VMi TECHNICAL SERVICE BULLETIN (DOC #TS-WI-0421)

VMi Spindle Mount Bracket Replacement for Select Model year Pacifica Minivans

Pacifica Spindle Mount Upgrade

Document Number: TS-WI-0421

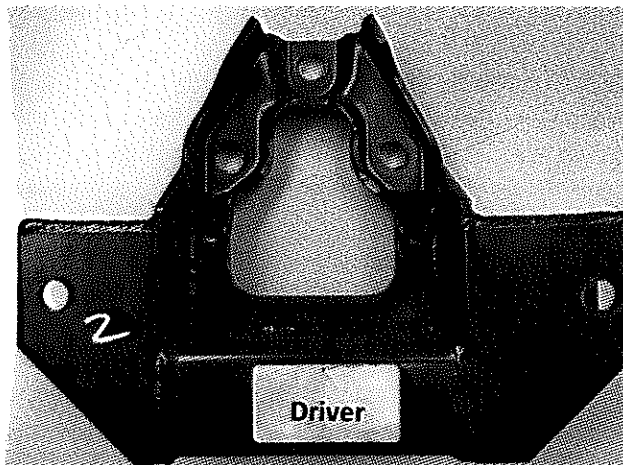
VMI has re-designed the bracket using different manufacturing processes to FURTHER increase longevity.

VMI Now has the new brackets available for any of our customers that would like to upgrade their suspension with these new stamped brackets. They are being offered at no cost to the customer and VMI is willing to pay for the shipping and installation for these assemblies

Example of a stamped bracket

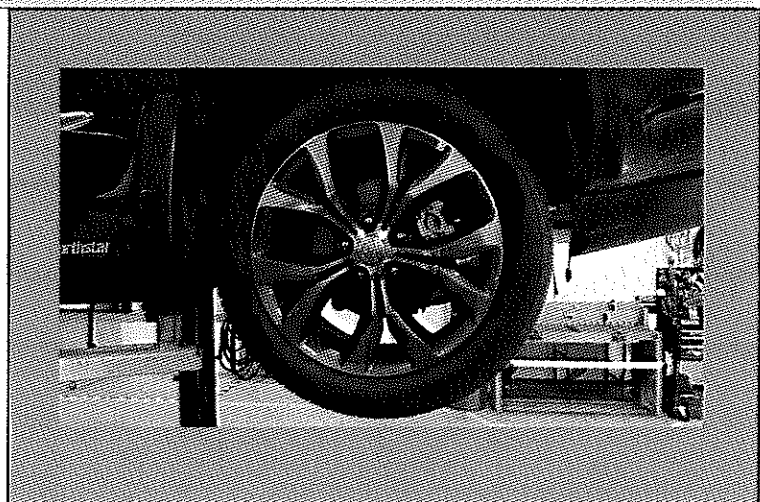
IMPORTANT: Prior to performing this bulletin, ensure the vehicle currently has brackets assembled by welding and does NOT have STAMPED brackets
